22 ESBWR PRA CHANGES

The ESBWR Design Certification PRA is being developed in parallel with plant design details. Already, significant safety benefits have been added to the ESBWR design based on PRA insights. To account for the effects of design changes on the PRA model, a PRA model update is performed so that the changes to PRA results can be quantified, evaluated, and applied to the design process. An update takes several months to perform. As such, it is a static representation of the plant that is based on the design information accumulated up to a specified point in time. The design phase is a dynamic process because additional detailed design information is still being developed in order to implement the functional design described in the Design Control Document. These design details enhance the understanding of the structures, systems, and components in the PRA model, and thus reduce uncertainties and eliminate assumptions. Continuing development of design details has a positive effect on the risk profile; however, the published PRA results do not account for up-to-date design information.

The PRA model update process accounts for this by including a "delta document," i.e

Figure 22.3-16 Reactor Vessel Rupture Event Tree

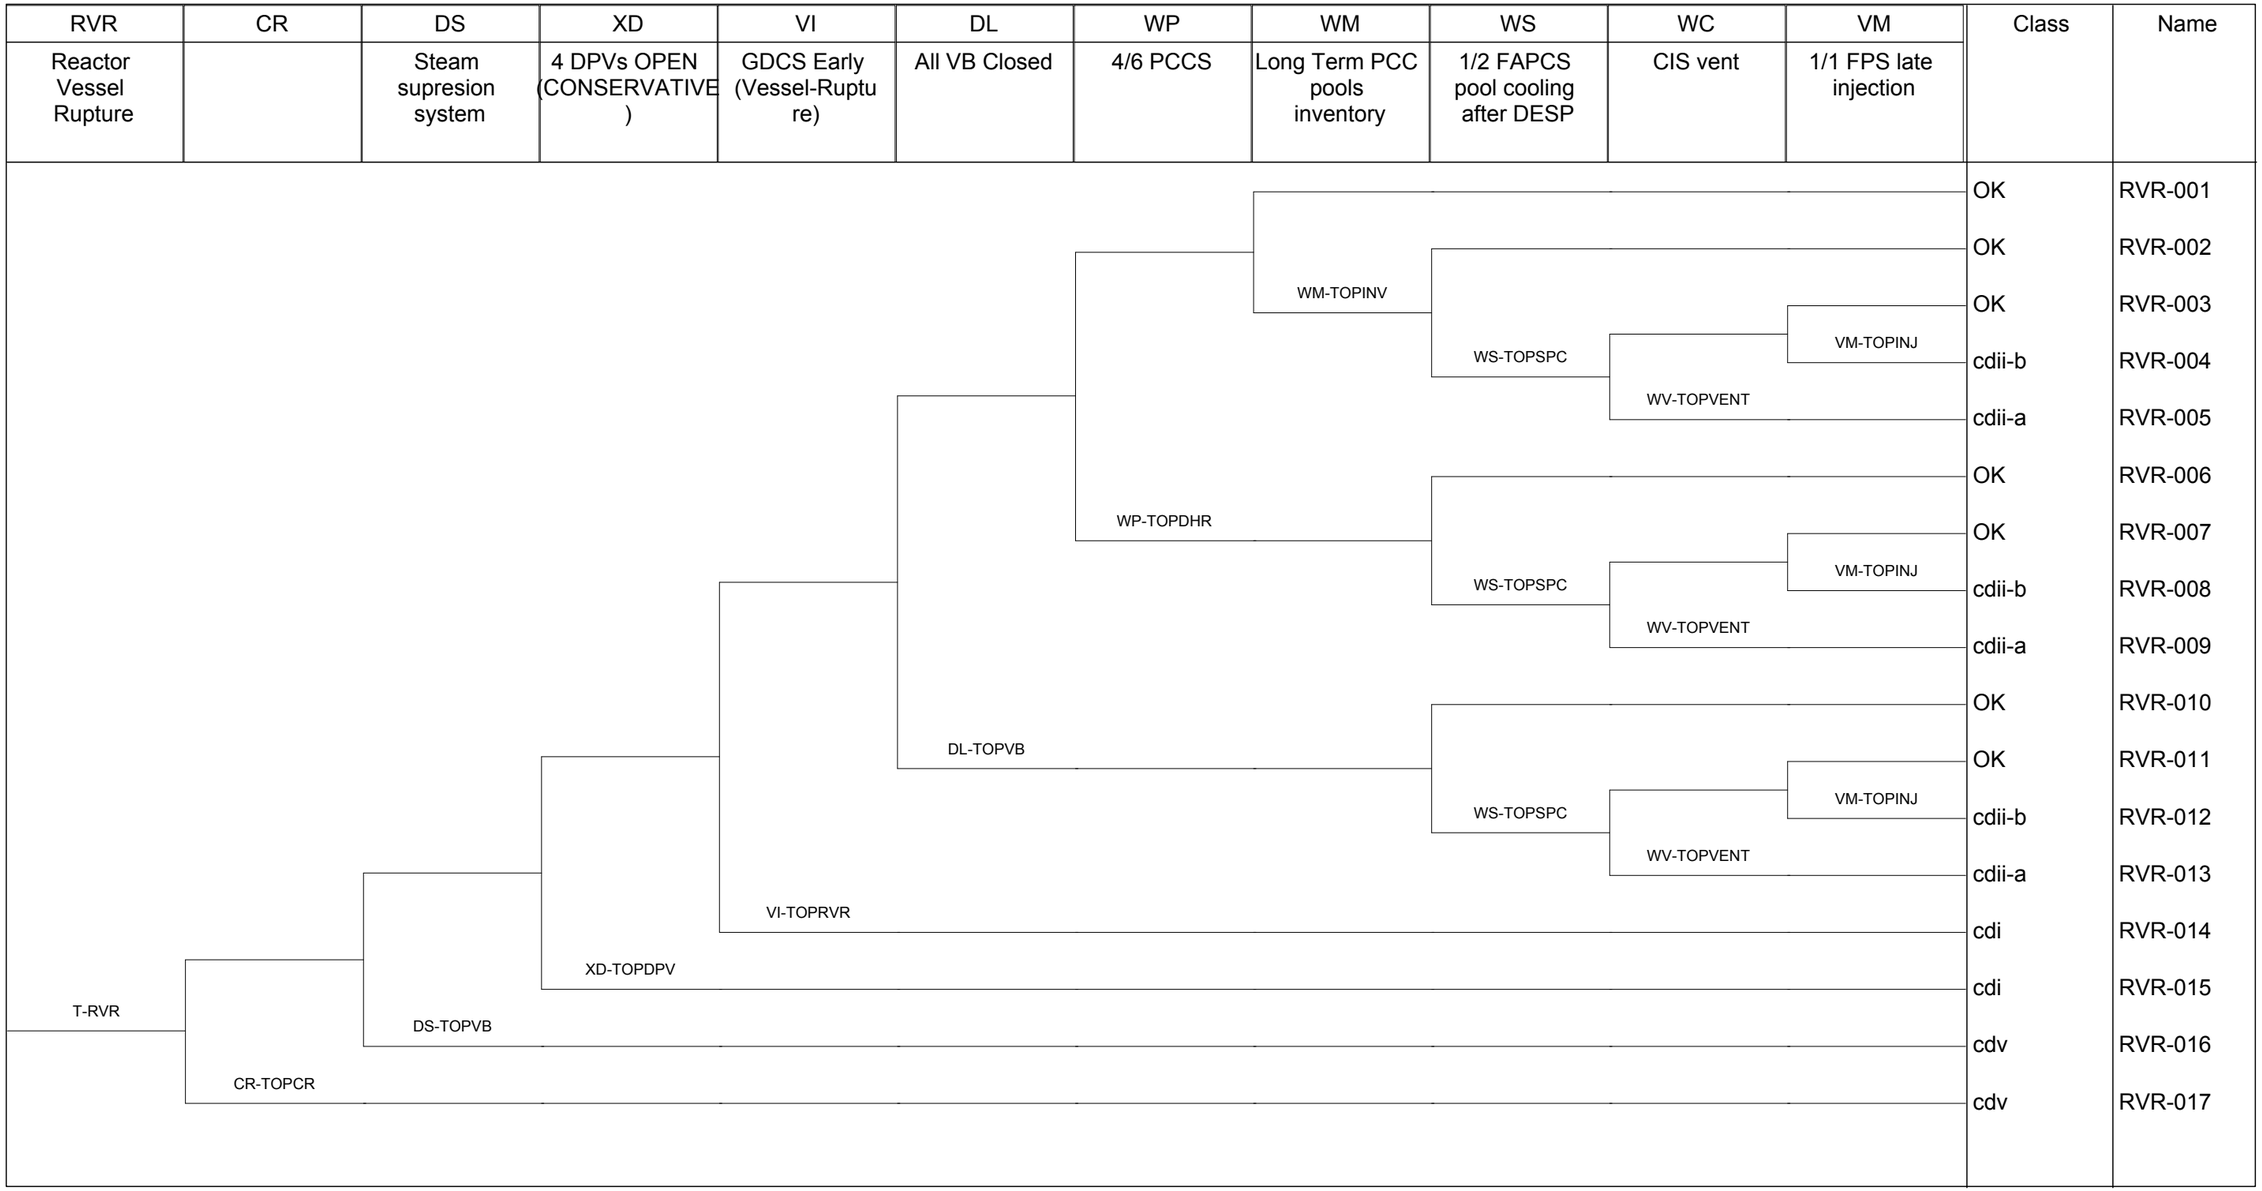
(1) The vessel rupture event tree (RVR) has been updated to explicitly address reactivity control. The Revision 2 event tree assumed that frequency of vessel rupture combined with the probability of failure of RPS was insignificant. This change resulted in a new sequence RVR-017, which was defined as a class cdv sequence.

Figure 22.3-17 Small Liquid LOCA Event Tree

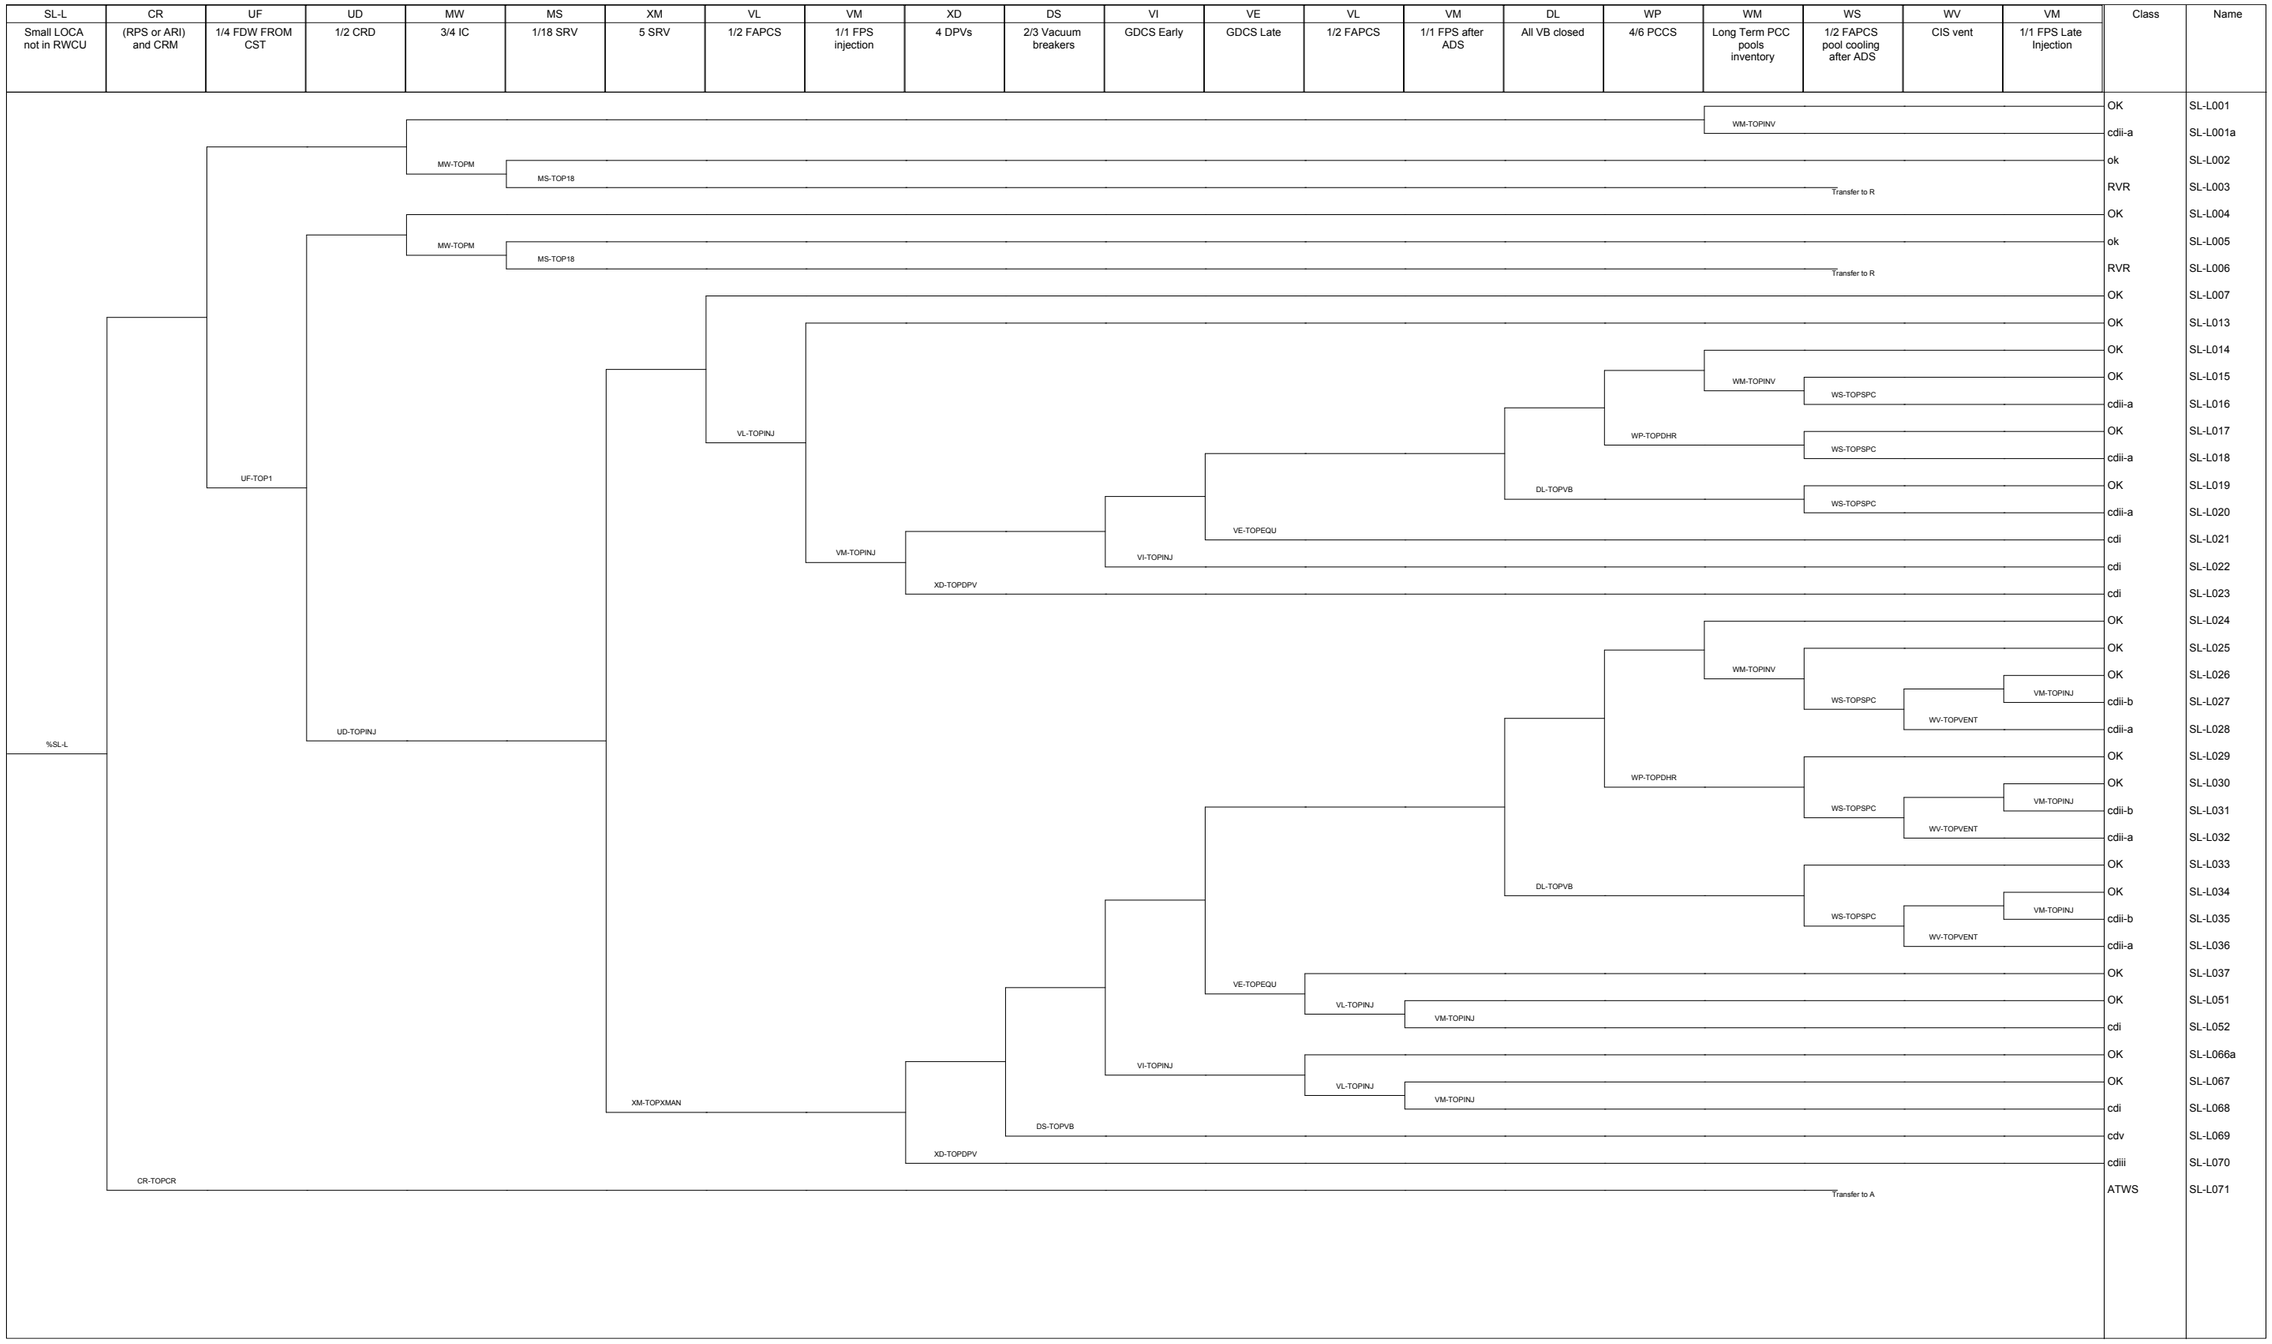
- Event WR (1/2 RWCU/SDC) has also been deleted from the small liquid LOCA event tree (SL-L), which resulted the removal of the success sequence SL-L053 (core ok).
- Revision 2 SL-L event tree was not modeled consistently as other event trees with respect to the GDCS success criteria, which were reflected in the VI and VE events (GDCS injection and equalization). To remove the inconsistency, event

VE has been deleted from the Revision 3 sequences after event VI failure. This change effectively removed sequences SL-L054 through SL-L066.

(3) In the Small Liquid LOCA (SL-L) event tree, event VL (1/2 FAPCS) has been evaluated prior to VM (FPS after ADS) injection in sequences SL-L067 and SL-L068. This change resulted in a new sequence SL-L066a (core ok).

Figure 22.4.7-1 Suppression Pool Cooling Fault Tree top

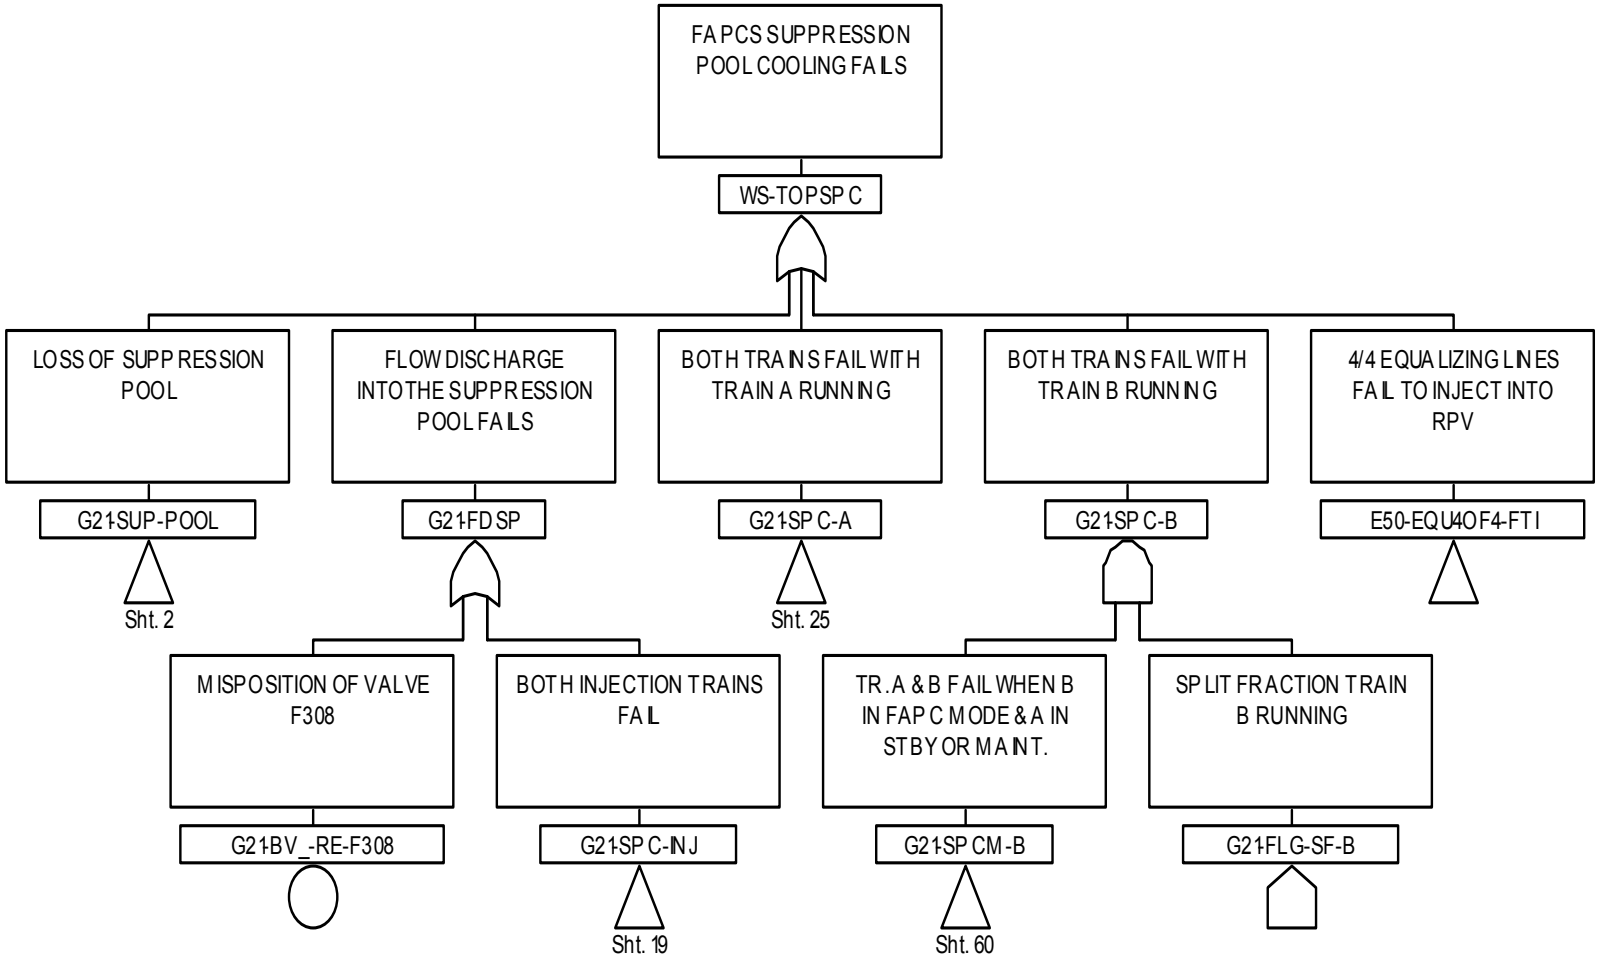
GDCS equalizing lines have been added to the logic for the two top events for SPC previously in the model. The gate from GDCS - E50-EQU4OF4-FTI has been added to the logic for both WS-TOPSPC and WS-TOPSPCL. Any one equalization line opening is required to successfully support SPC. Thermal hydraulic analysis shows equalization is required for successful SPC in sequences where maintaining a recirculation loop is required. This change was completed by adding existing GDCS logic to the fault tree for SPC. Figure 22.4.7-1 shows the top of the SPC fault tree with the GDCS equalization transfer event included in the logic.

Figure 22.4.9-1 Feedwater Isolation Valve Configuration

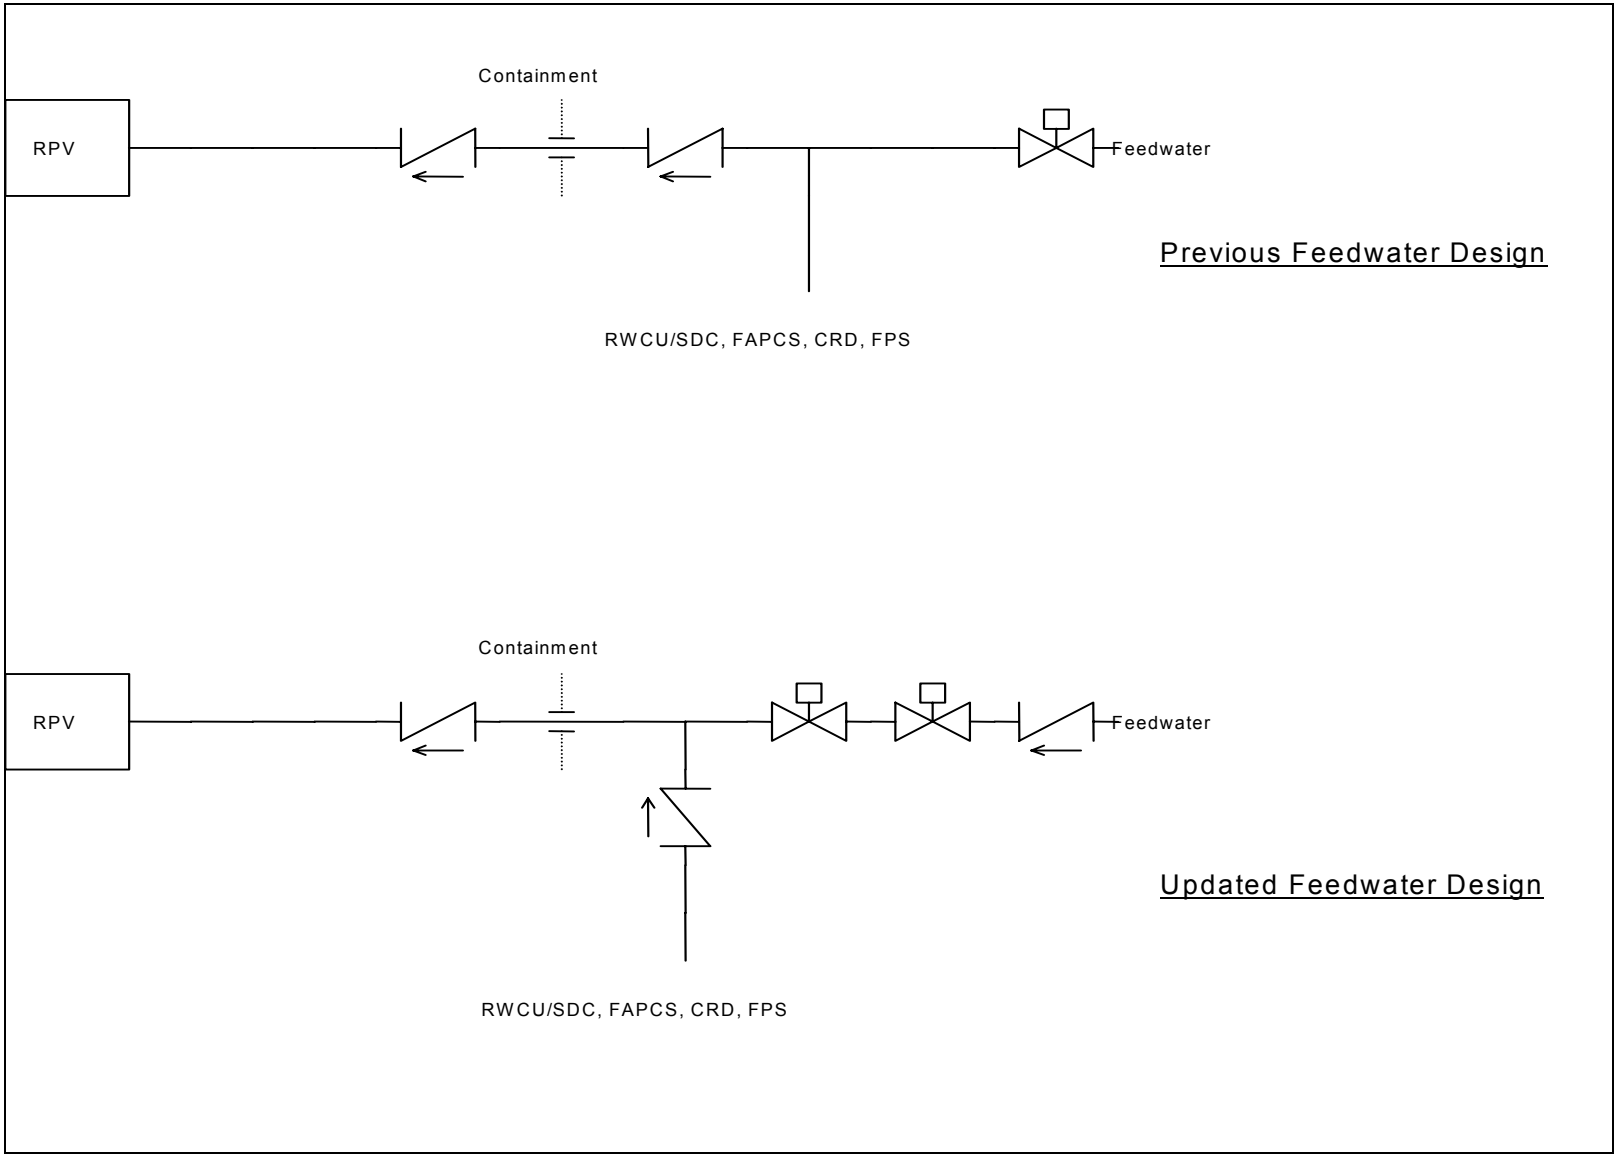
Main Feedwater Lines A and B previously each had a single Motor Operated Valve (MOV), and two check valves, one of which was an air assisted check valve that could be closed. The updated design has a check valve, two MOVs, and then a final check valve. See figure 22.4.9-1 for a simplified diagram showing the old and new configuration. Simply stated, a single MOV was added to each line, and the location of one check valve was changed. The design change was to provide a more effective containment isolation arrangement, and a more effective feedwater isolation for inside containment line breaks. From the PRA model perspective, the new design added a single MOV to each line that already had an MOV and multiple check valves.

Another feature of the design change is the location of the pipe connections for RWCU/SDC, CRD, FAPCS, and FPS. A single connection on each feedwater line allows injection from these systems. FAPCS, FPS, and train B of RWCU/SDC are connected to feedwater line A. The other train of RWCU/SDC and CRD are connected to feedwater line B. The previous design had the connection upstream of the two check valves (see figure 22.4.9-1). The new design has the connection upstream of only a single check valve, but added a check valve to the connecting line right near the connection point to the main feedwater lines. The net result is that the number of valves and valve types that need to function to support these systems has not changed at all. The number of valves that can lead to failure of all systems has been reduced to one on each line.
